**Specification for radio disturbance and immunity measuring apparatus and methods –
Part 1-4: Radio disturbance and immunity measuring apparatus –
Ancillary equipment – Radiated disturbances**

CORRIGENDUM 1

Figure C.8 – Validation factor for a large loop-antenna of 2 m diameter

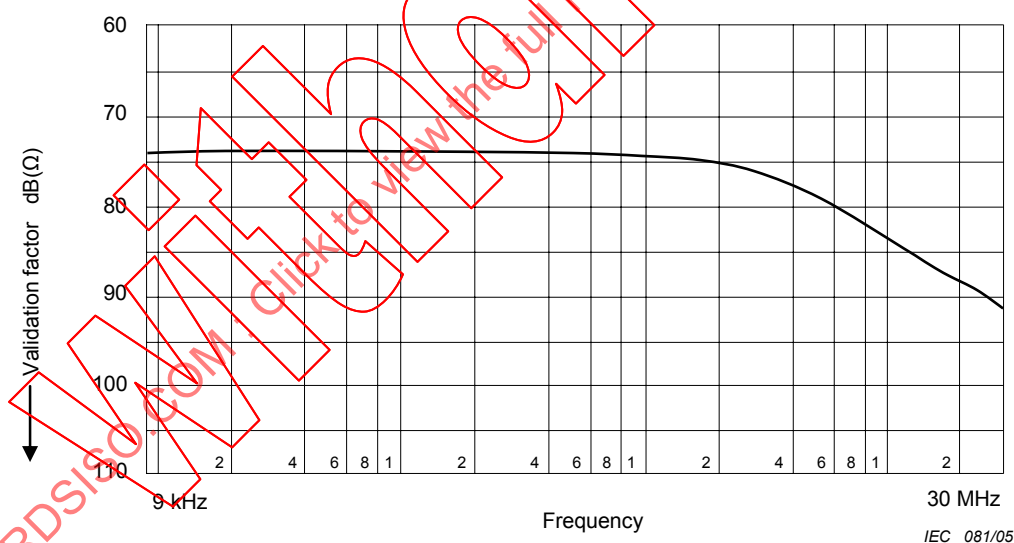
Replace the existing Figure C.8 by the following new Figure C.8:

Replace the third paragraph of Clause C.4 as follows:

In each of the eight positions, the validation factor [expressed in $\text{dB}(\Omega) = 20 \log(V_{go}/I_l)$] of the open circuit voltage of the RF generator (V_{go}) and the measured current (I_l) shall not deviate more than ± 2 dB from the validation factor given in Figure C.8.
